STAFF REPORT & RECOMMENDATION
Port of Woodland
Guild Road Industrial Park Phase I

ISSUE DATE: December 28, 2018

Land Use Application No.: SPR2018-004/CAP2018-001

C:\Users\amacc\AppData\Local\Temp\AcPublish_10512\PWL02 - 13-17 - Planting Plan.dwg

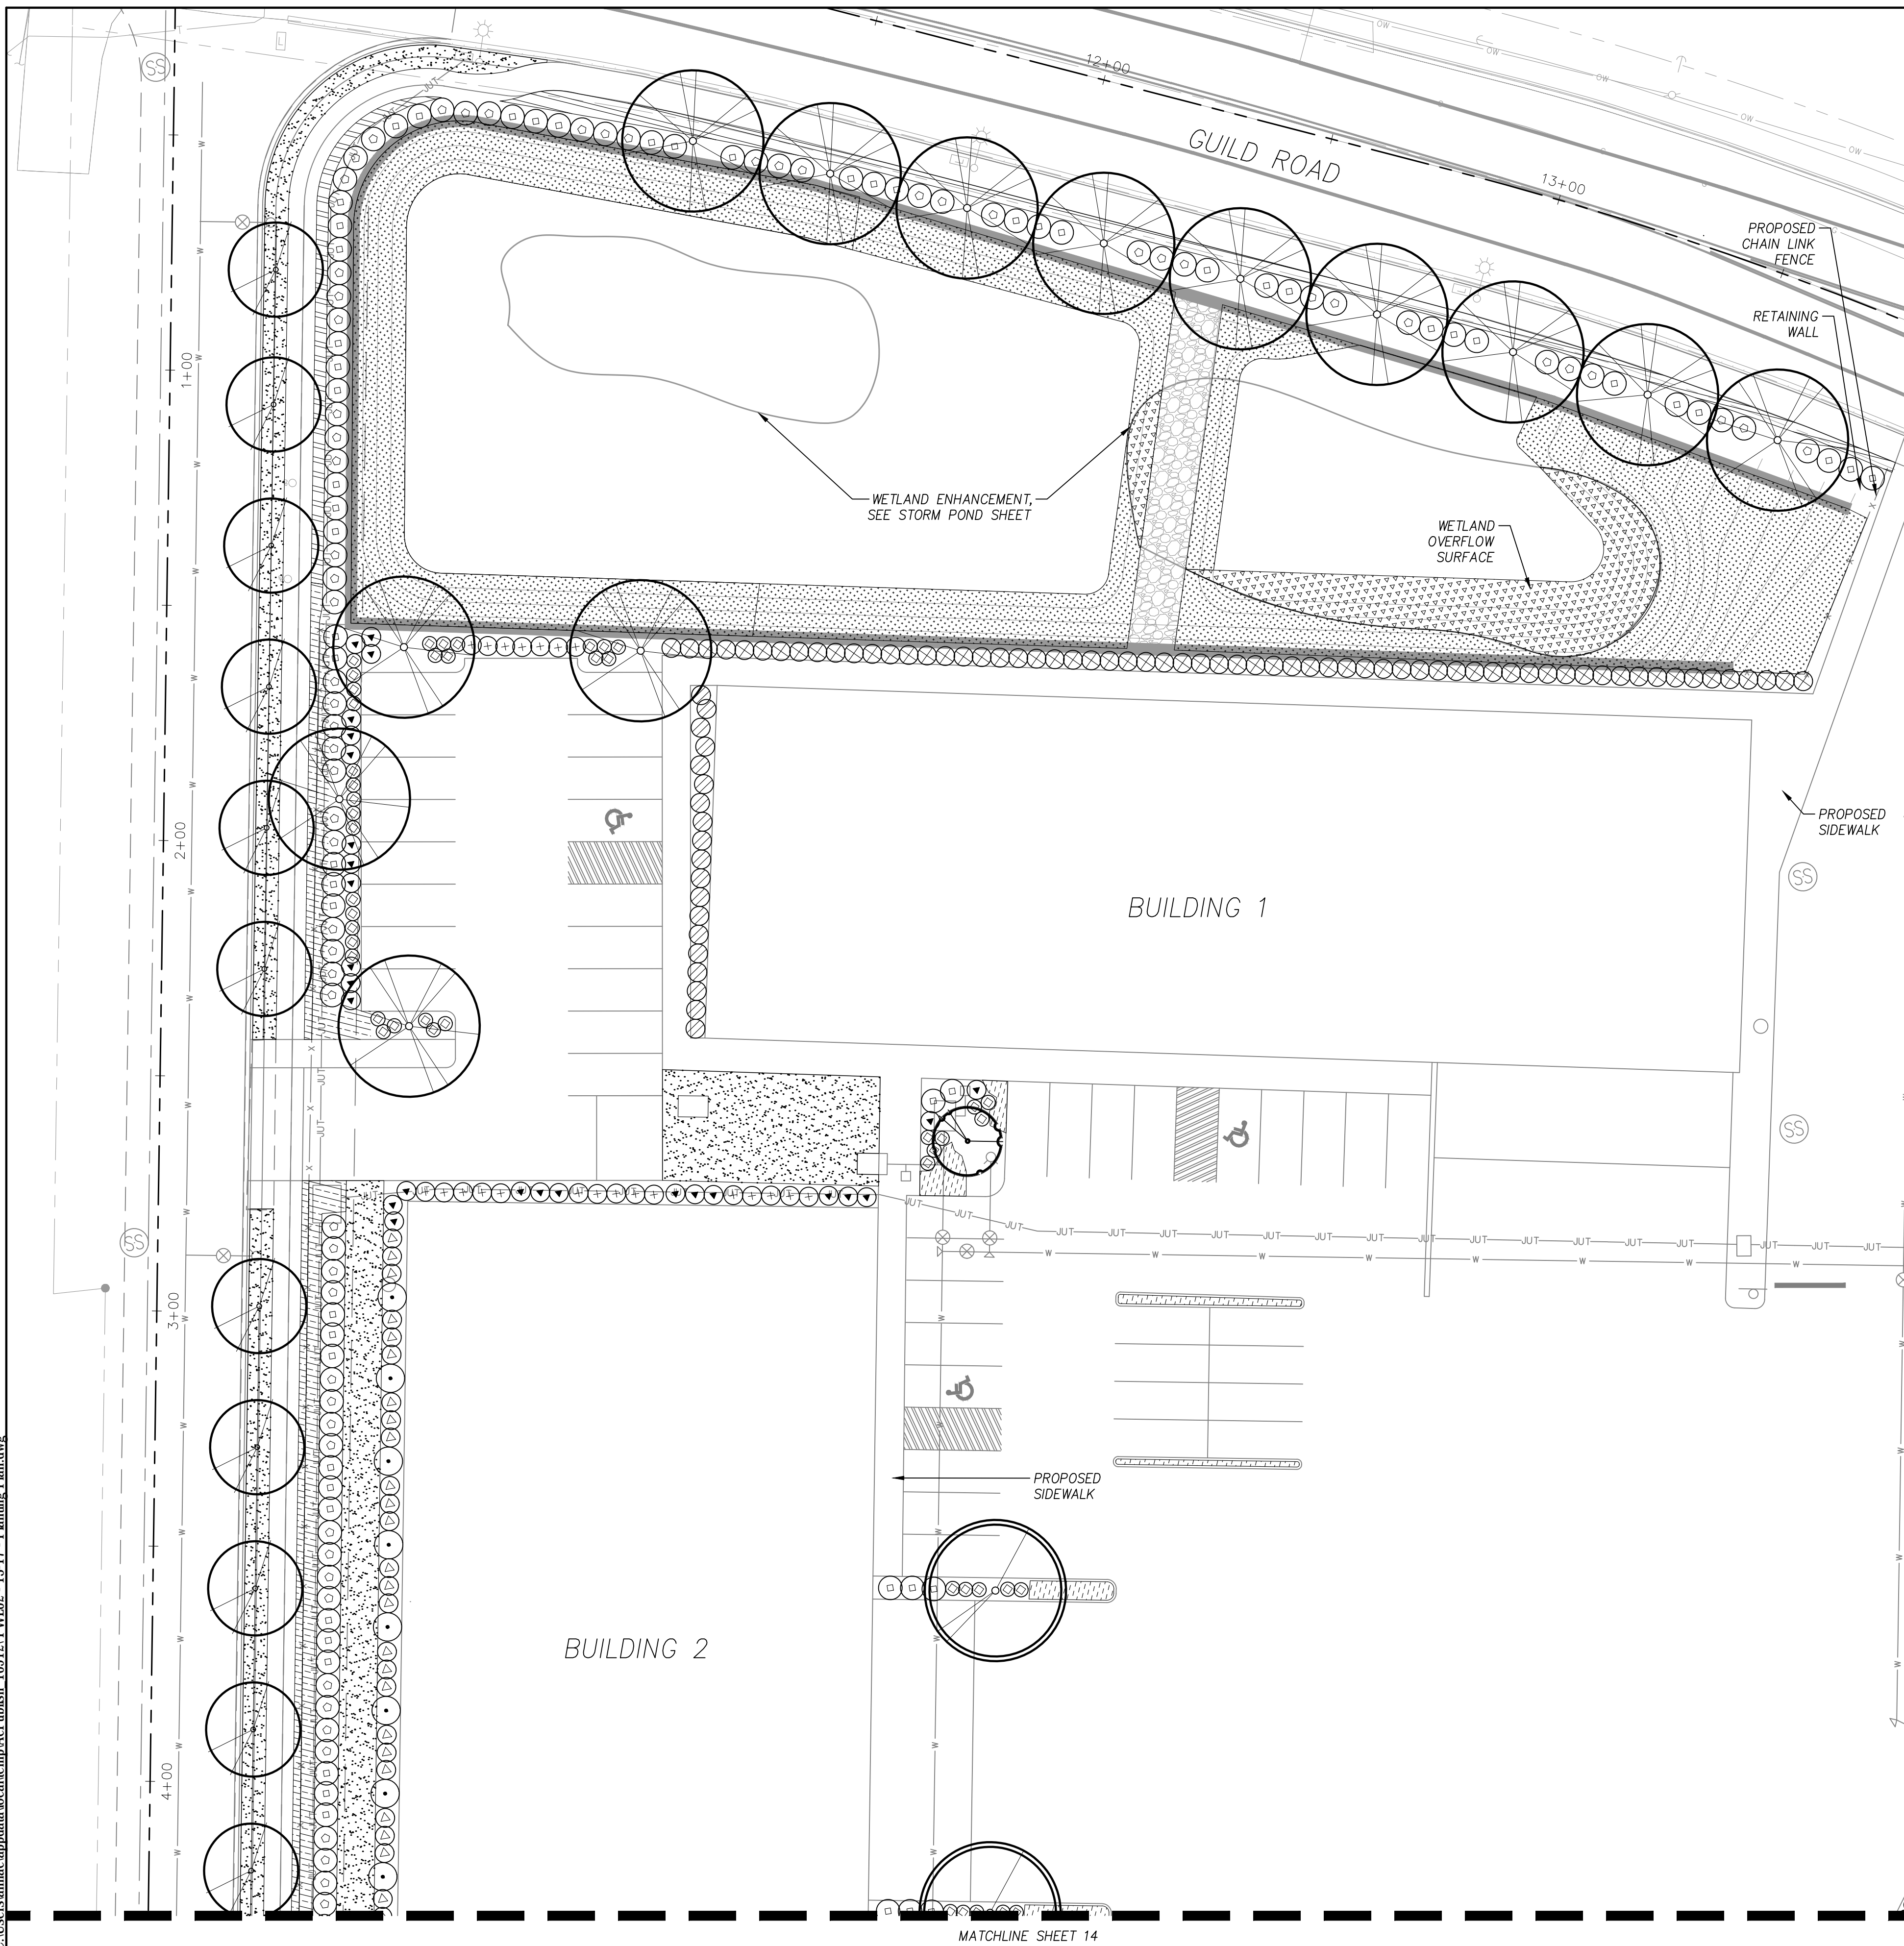
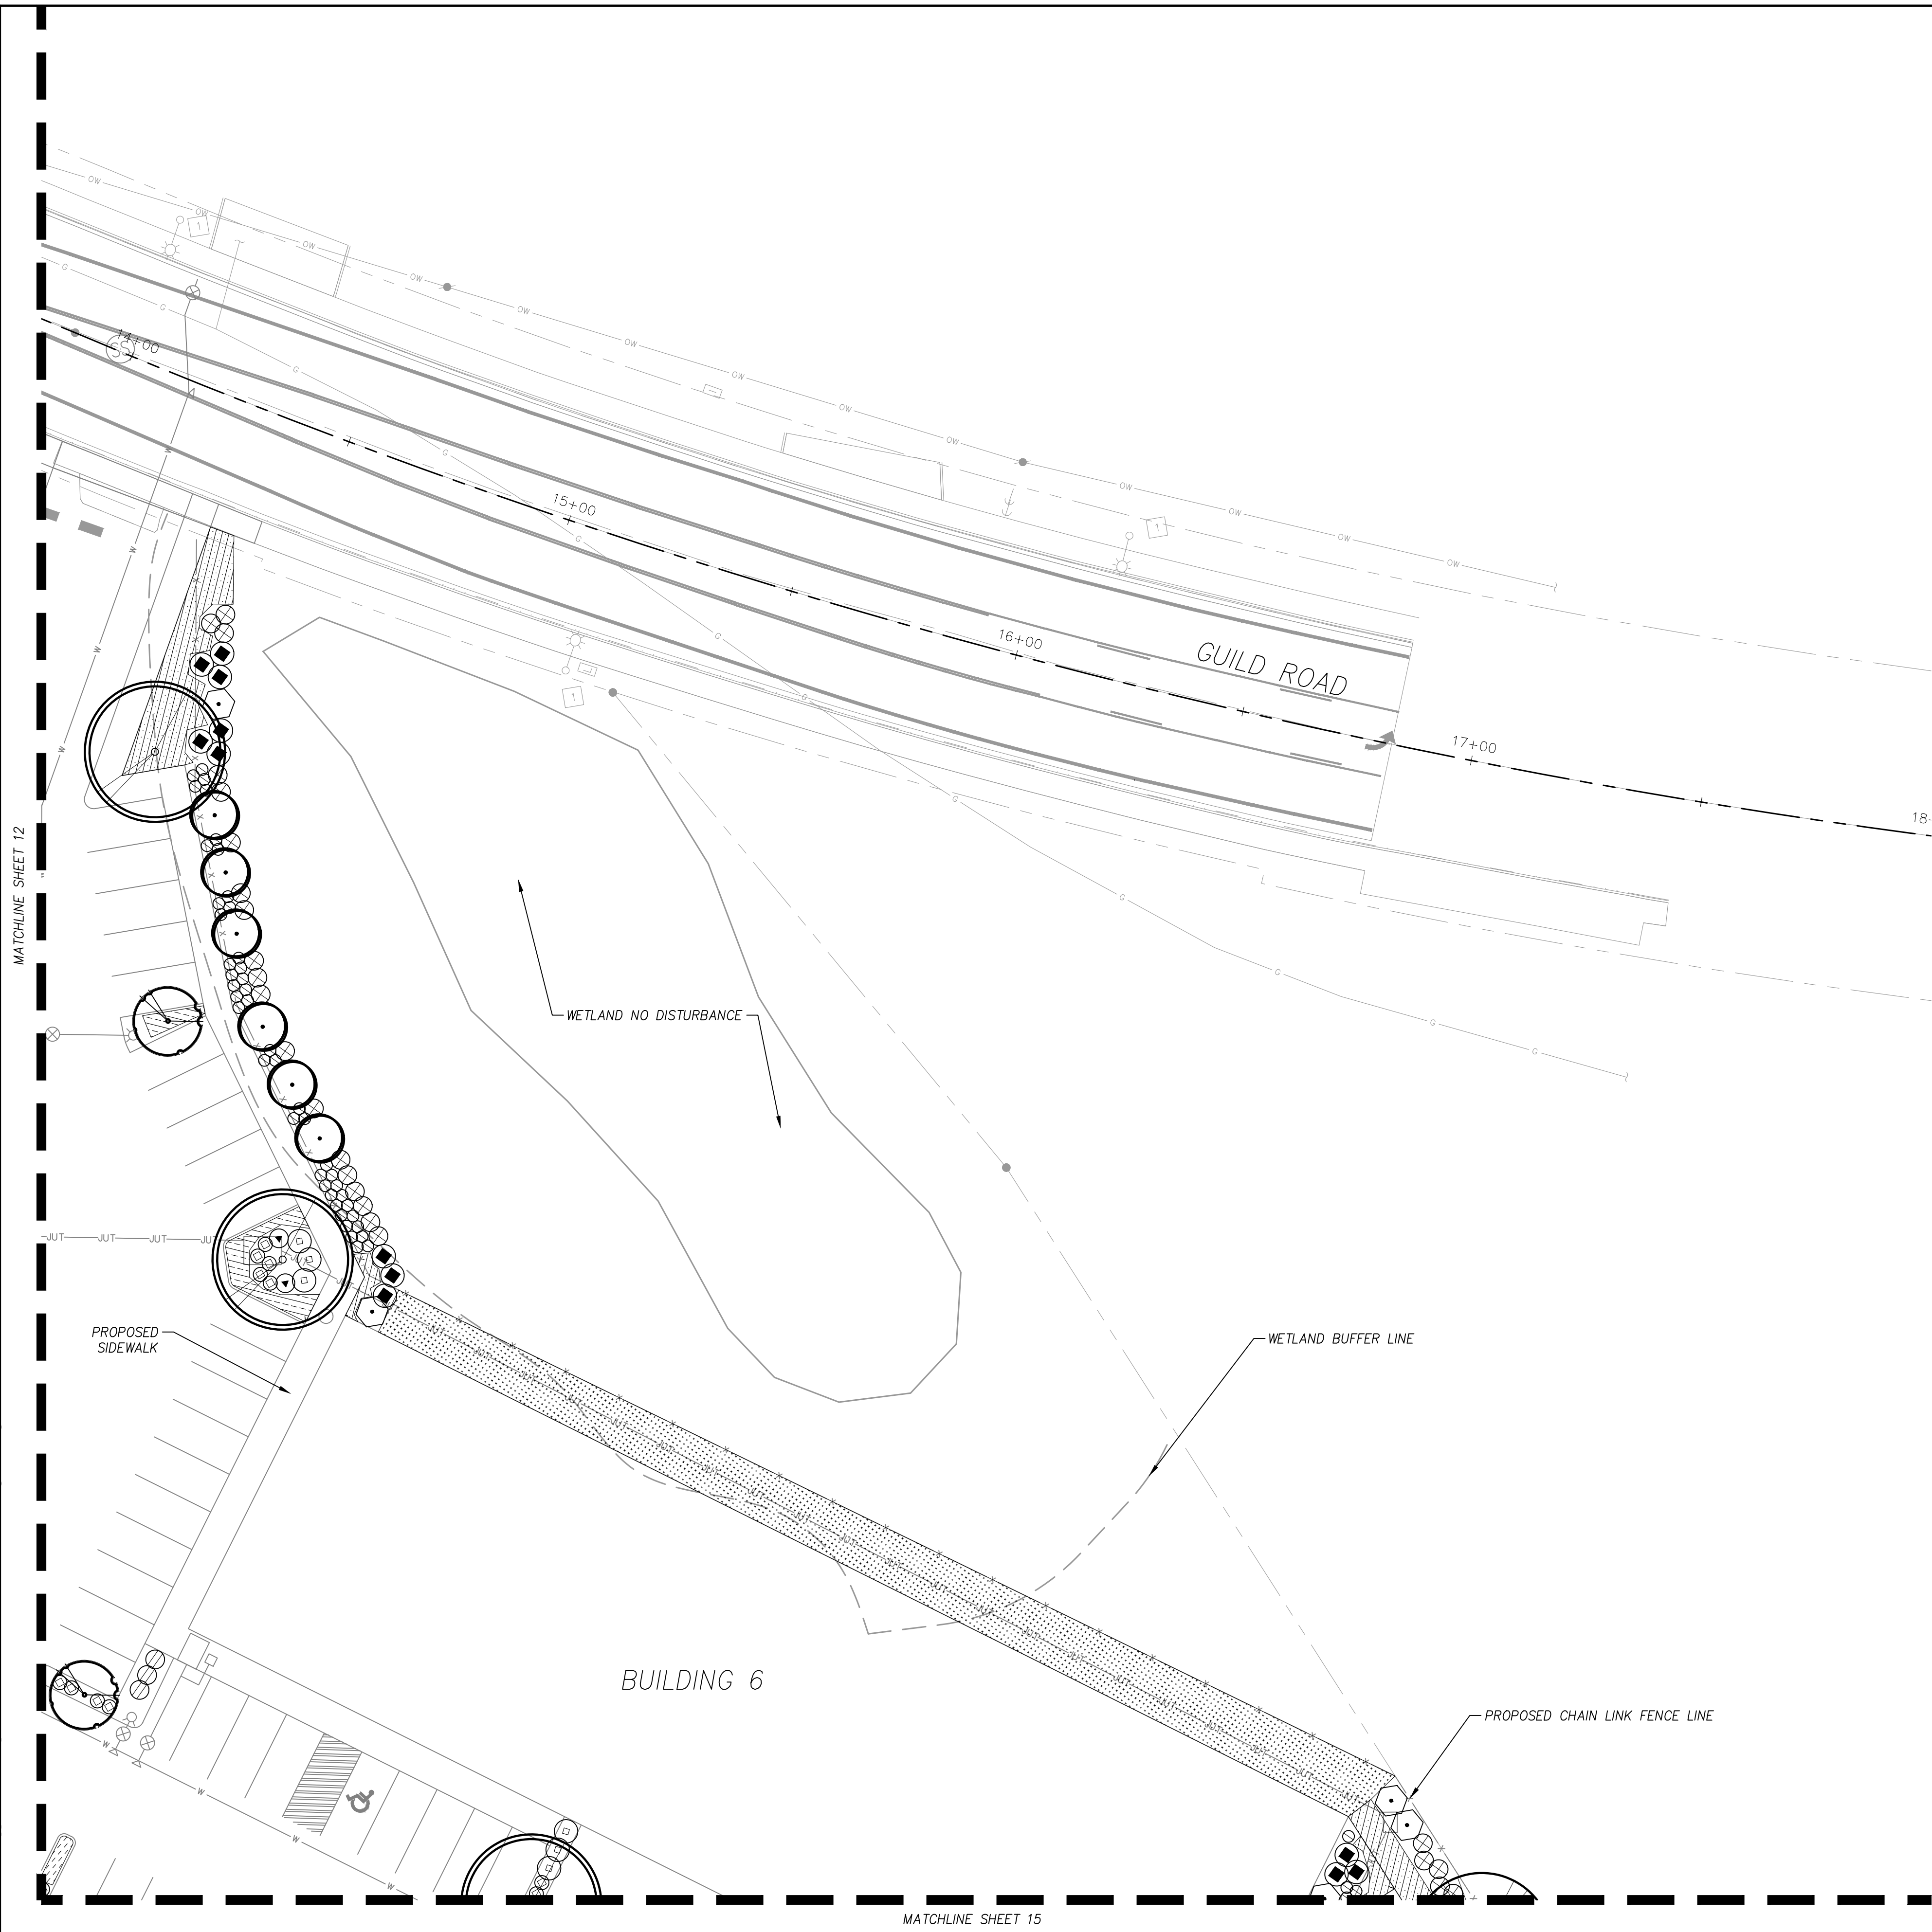
Finding 12: The applicant has submitted the landscaping plan material with the application material as required by WMC 17.44.133 and .134. except it was not stamped and signed by a qualified professional.

Finding 13: The proposed master landscaping plan appears to comply with the standard of WMC 17.44.135 in terms of: landscaping materials; shrub sizing and spacing; tree size and spacing; and non-plant ground covers. For additional comments see below. Implementation of the landscaping will be required prior to occupancy of the first building on the site. (See Site Plan Condition #15)

Finding 18: Landscaping plant selection as shown on the plan includes several species that are not native to the area AND includes some species that can be considered invasive species. Normally, each plant selection includes language that allows for an "approved equal" but this plan does not include that notation. Invasive species should not be included in the planting plan. (See Site Plan Condition #14)

Finding 19: Requirements for Maintenance and Irrigation. The use of drought-tolerant plant species is encouraged and shall be required when irrigation is not available. Irrigation shall be provided for plants that are not drought-tolerant. In this case, note 11 from Page 13 of the plans clearly indicates that irrigation will be provided by others.

14. The master landscape plan shall be modified as necessary to ensure that no invasive species are included in the plantings.
15. Landscaping shall be installed prior to any building on the site being occupied.
